Appendix 13.1

Aviation

Appendix A to Chapter 13 – Aviation

Figure 4

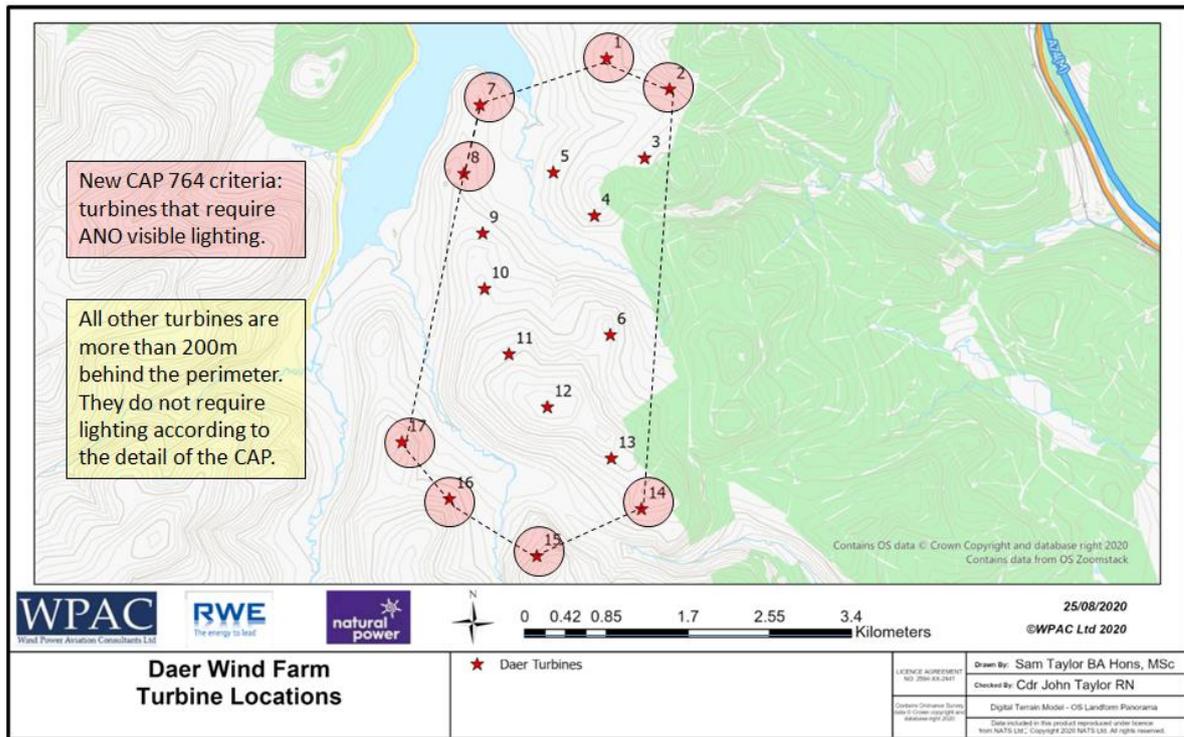
5. Figure 4 shows a lighting scheme that is compliant with the latest draft CAP 764 release. Eight of the seventeen turbines have ANO visible lights. However, the distance between T8 and T17 is close to 3km and the distance between T2 and T14 is around 4km. Accordingly, the CAA may specify lighting over and above the CAP 764 and require lighting on turbines T6 and T10 and possibly T3. Figure 5 shows this lighting arrangement. However the layout at Figure 4 is technically compliant and has been submitted to the CAA for approval.

Figure 6

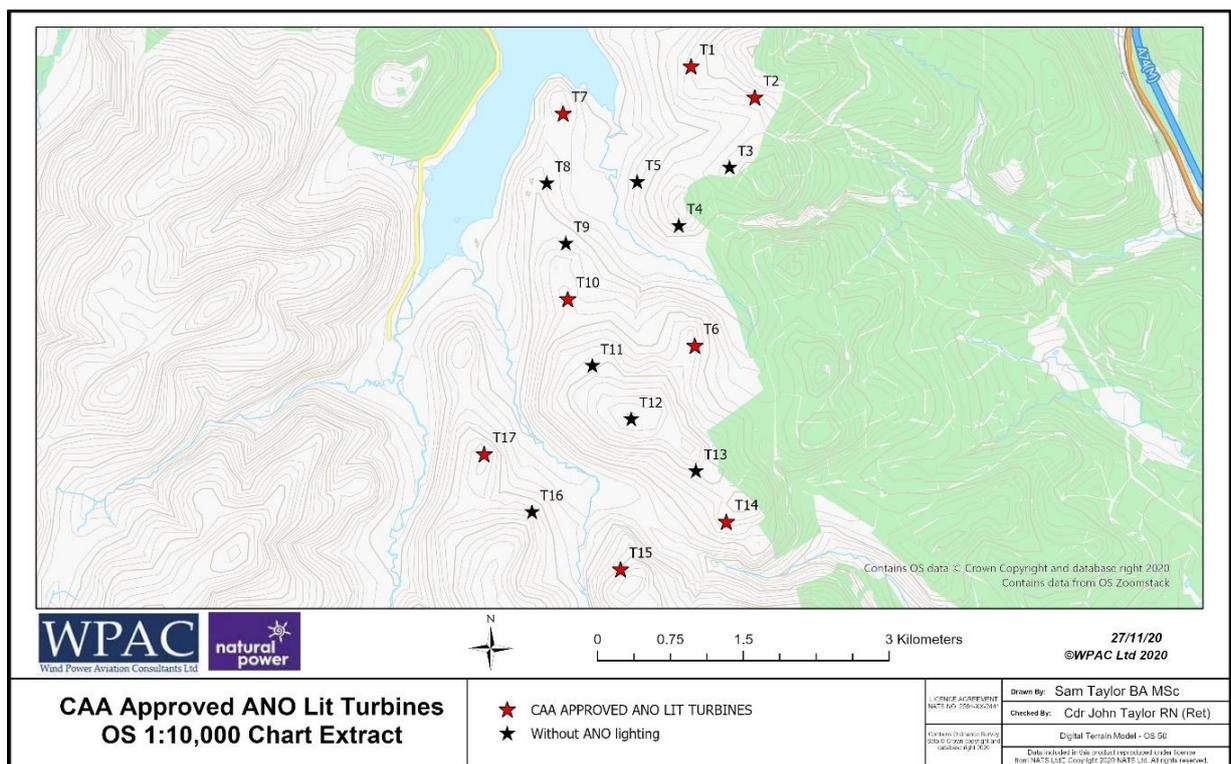
6. The CAA responded to the proposal under Reference CAA/Windfarms/DaerWF letter dated 17 November 2020 agreeing a variation to the lighting requirements specified in the ANO Article stating the following requirements:
- medium intensity steady red (2000 candela) lights on the nacelles of Turbines 1, 2, 6, 7, 10, 14, 15, and 17;
 - a second 2000 candela light on the nacelles of these turbines to act as alternates in the event of failure of the main light;
 - the lights on these turbines will be capable of being dimmed to 10% of peak intensity when the visibility as measured at the wind farm exceeds 5km;
 - infra-red lights to MoD specification installed on the nacelles of perimeter turbines, which consists of turbines 1, 2, 4, 6, 7, 8, 10, 12, 14, 15, 16 and 17.
7. The finalised CAA approved ANO lighting layout is shown in Figure 6 and the MOD IR lighting layout in Figure 7.

Figure 7

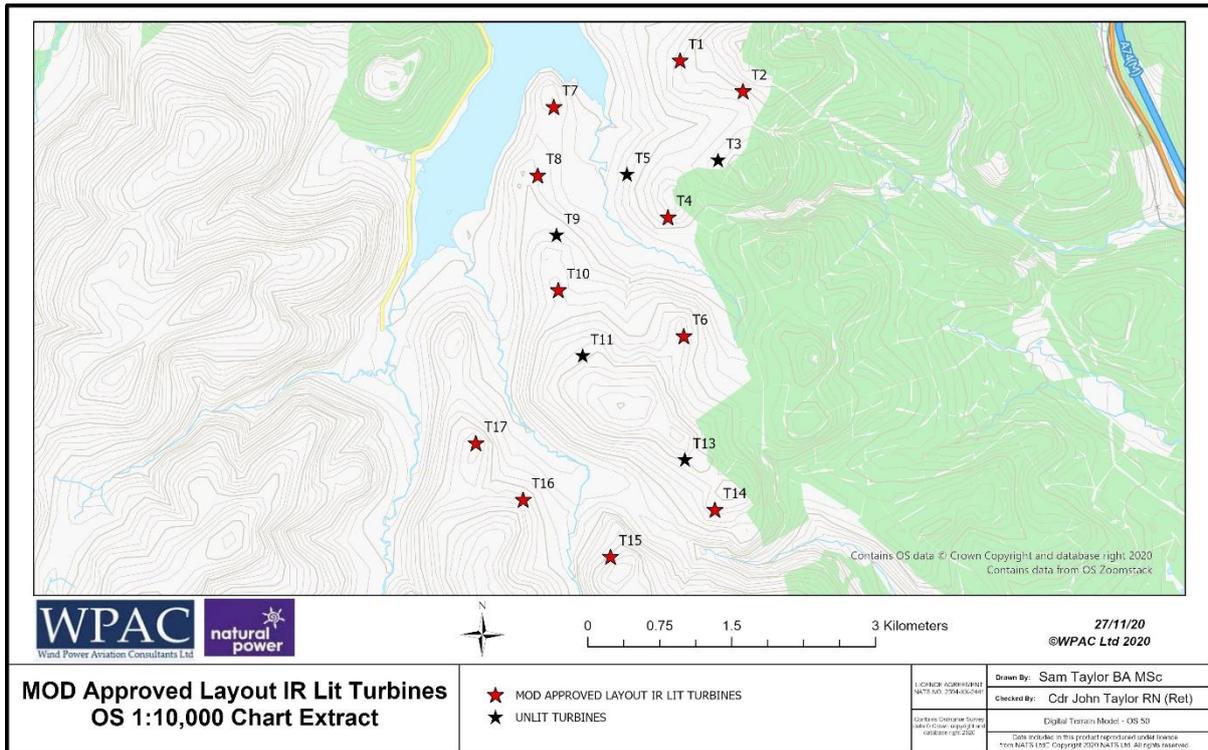
14. Figure 7 shows a lighting scheme that is compliant with the MOD Lighting Guidance in terms of perimeter turbines. Eight perimeter turbines are lit with IR lighting. However, as the perimeter lights are concentrated to the north and south of the site, extra central/gap fill lights are fitted to central turbines as shown in the Figure.

15. The MOD (DIO) confirmed by email on 20th November that the IR lighting scheme had been approved, stating: *Daer Reservoir (DIO 10045032) - This has been reassessed both technically and operationally as the layout has been updated since we were last consulted, I can confirm that the MOD is content with the lighting proposal you have provided. '*
